Stage 1 RSA & Designer's Response

Road Safety Audit Stage 1

Section 278 Works

Report Title:	Interbridges Site, Emsworth Road Safety Audit Stage 1
Document reference:	BR/24/6096/1/MM
Prepared by:	M & S Traffic
On behalf of:	Hampshire County Council

APPENDIX B

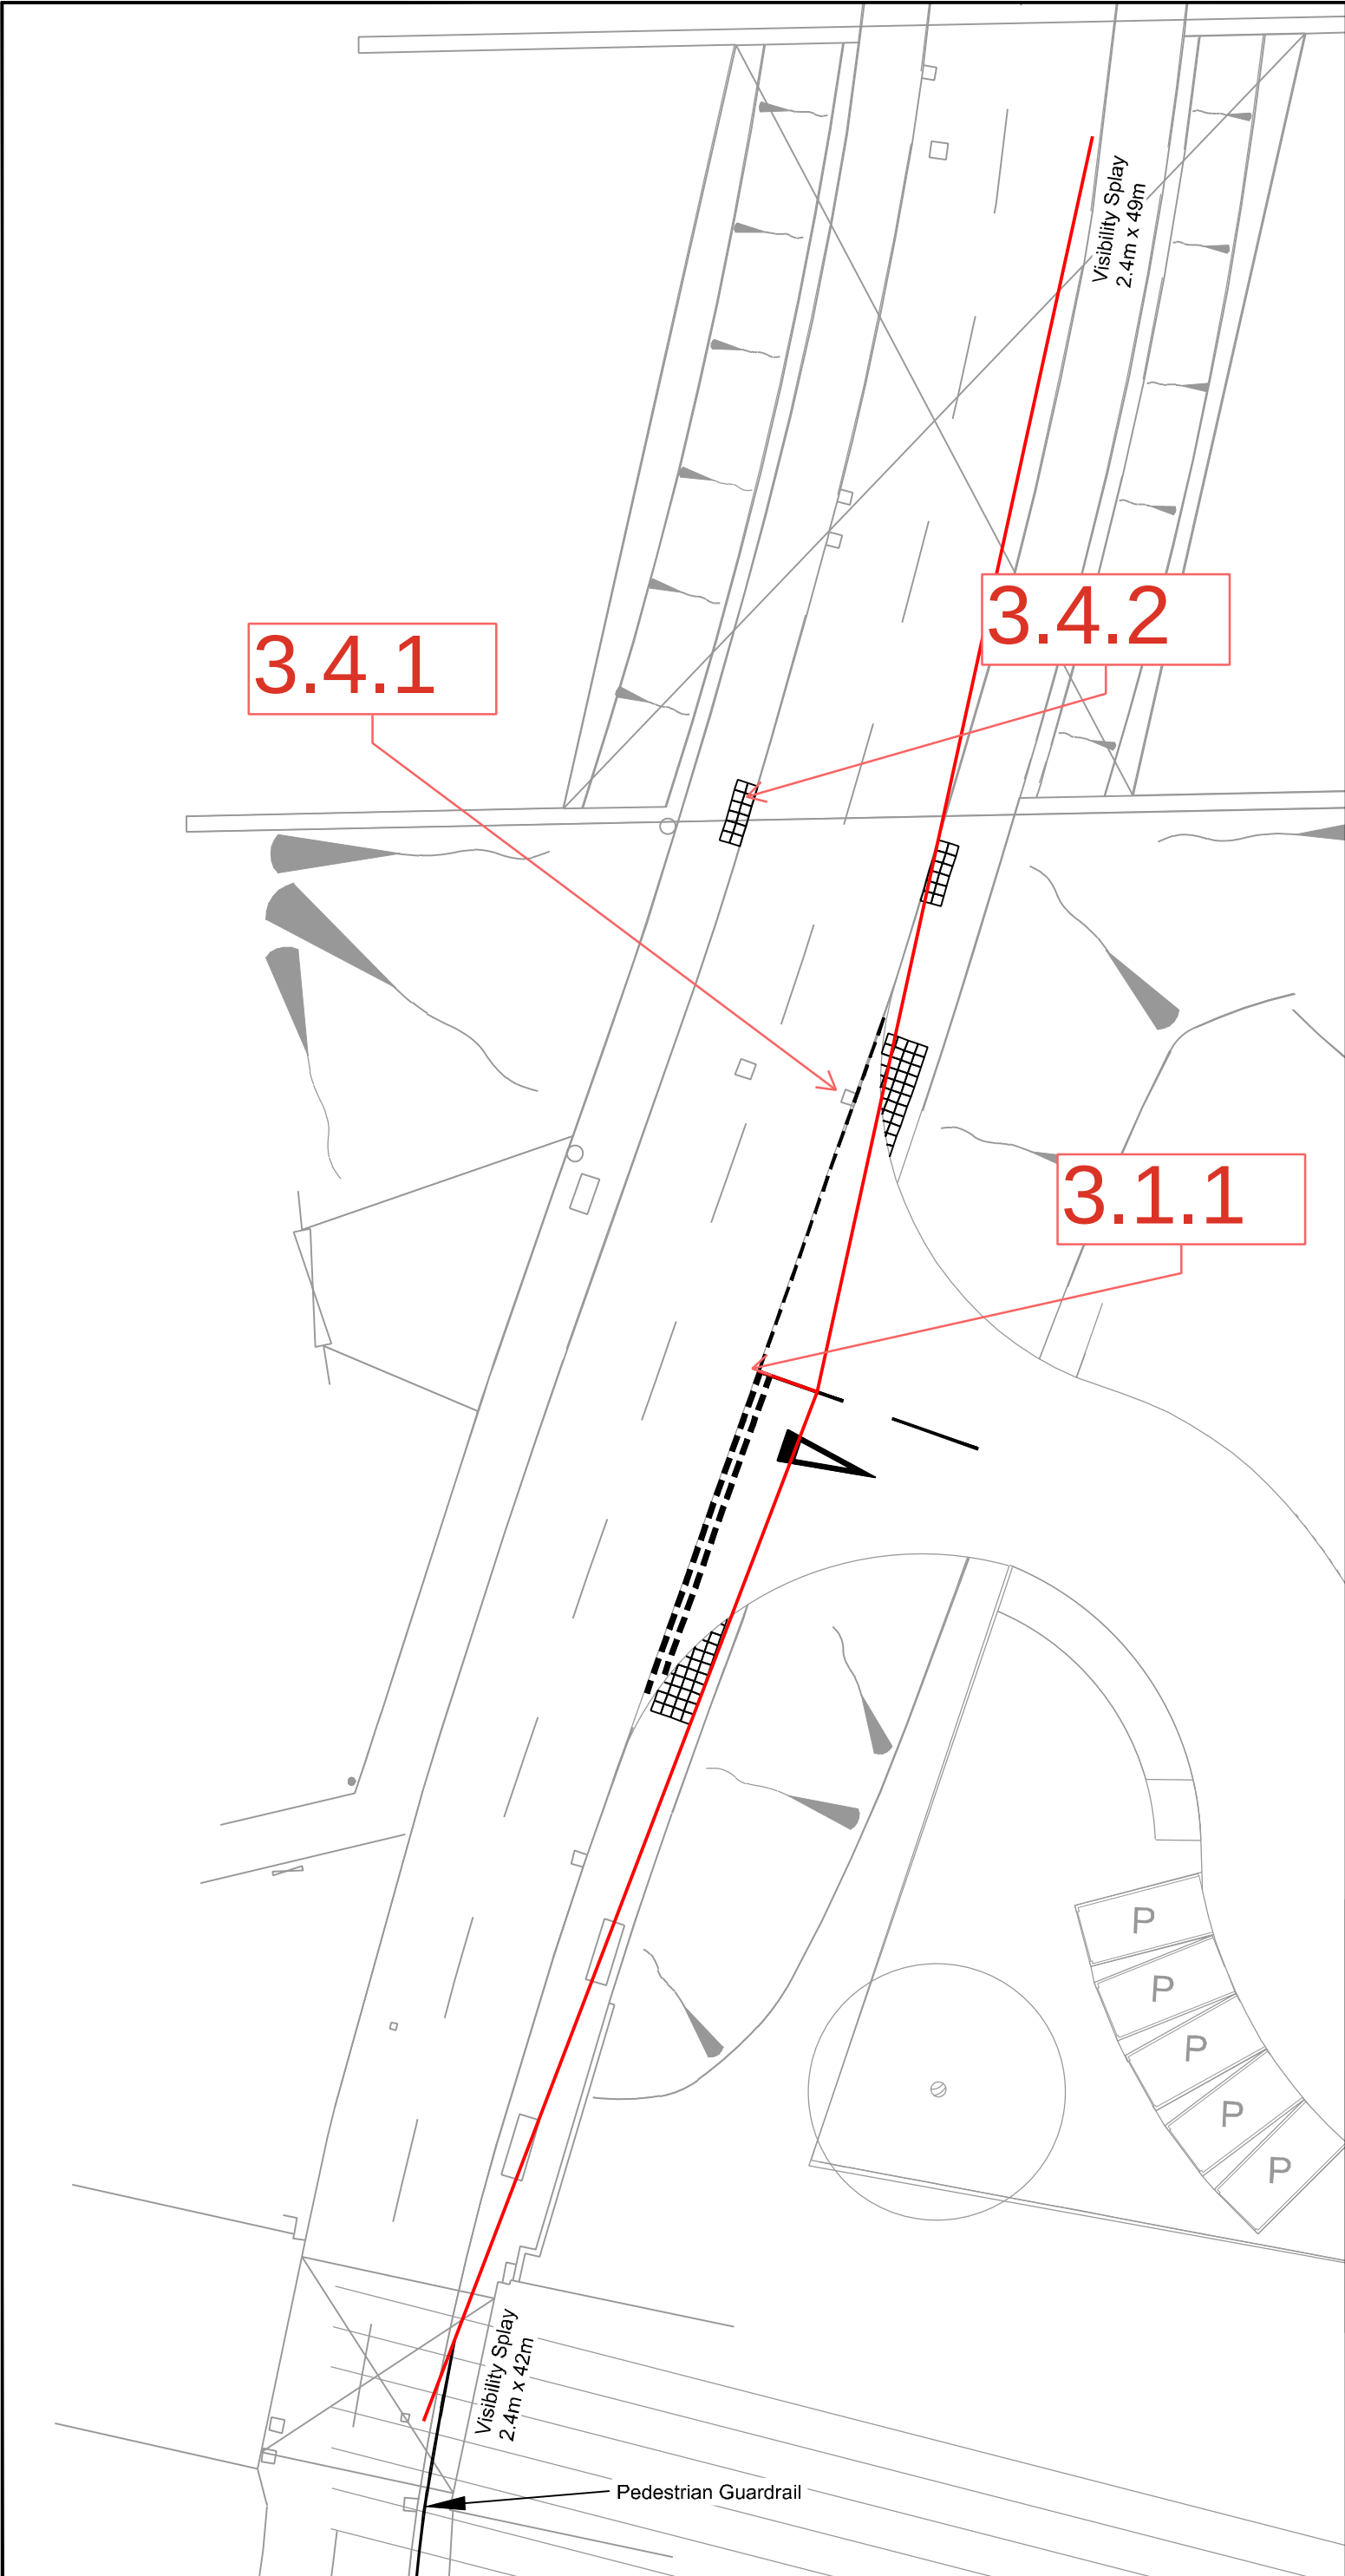
No drainage details have been provided for assessment, where the site and surface water could fall towards North Street. Surface water across the junction mouth could lead to loss of control collisions, particularly under braking conditions in wet / icy weather.

It is recommended that the carriageway should adequately drain and not pond and that drainage details should be provided at Stage 2 Safety Audit.

At the proposed junction there is an existing gully cover within the junction mouth, which could present a hazard for cyclists and powered two-wheel riders, particularly when leaning over to enter the junction. This could lead to could to loss of control collisions for cyclists or powered two-wheel riders.

It is recommended that the gully should be repositioned out of the junction mouth.

North Street curves as it goes through the underpass, where road users could be emerging from dark to light conditions, in addition the underpass lighting is only on the eastern side. Road users may suddenly encounter a pedestrian crossing from a dark area – see figure 1 below. This could lead to sudden braking and rear end shunt collisions, or vehicle to pedestrian collisions.

It is recommended that a suitable lighting should be provided to illuminate pedestrians.

Plan attached showing the locations of the problems identified as part of this audit (location numbers refer to paragraph numbers in the report).

Item No.	RSA Problem	RSA Recommendation	Design Organisation Response	Auditors Response	Overseeing Organisation Response	Agreed RSA Action
3.1.1	Ponding of surface water could lead to loss of control collisions.	It is recommended that the carriageway should adequately drain and not pond and that drainage details should be provided at Stage 2 Safety Audit.	AGREE. Adequate surface water drainage will be provided. This matter will be addressed further at the detailed design stage.	Noted and accepted.		
3.4.1	Gully in the junction mouth could lead to loss of control collisions for cyclists or powered two-wheel riders.	It is recommended that the gully should be repositioned out of the junction mouth.	AGREE. The gully will be repositioned. This will be considered further at the detailed design stage.	Noted and accepted.

Item No.	RSA Problem	RSA Recommendation	Design Organisation Response	Auditors Response	Overseeing Organisation Response	Agreed RSA Action
3.4.2	Pedestrians crossing from a dark area could lead to sudden braking and rear end shunt collisions, or vehicle to pedestrian collisions.	It is recommended that a suitable lighting should be provided to illuminate pedestrians.	AGREE. Lighting is currently provided on the underside of the bridge. A review of its suitability will be undertaken at the detailed design stage.	Noted and accepted.
